# Access Compliance Report Public Rights-of-Way (Pedestrian Signals)

**Main Street:** IRVINE\_BLV **Cross Street:** TUSTIN\_RANCH\_RD **Location:** S

**ADA ID:** SGRK220103131631 **Signal Type:** One Push Button-APS **Overall Compliance:** No **Severity Scores:** BTN 1: 0 BTN 2: N/A No BTN: N/A

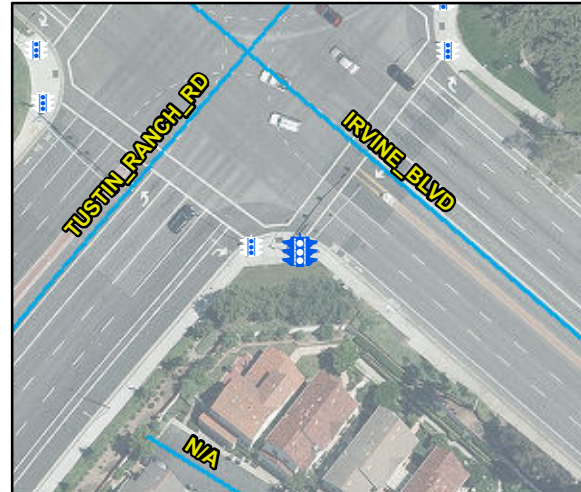
**OC Std/PROW:** MUTCD 4e.08

**Possible Solutions:** Replace Signal Push Button With APS Button. Remove & Relocate Sign.
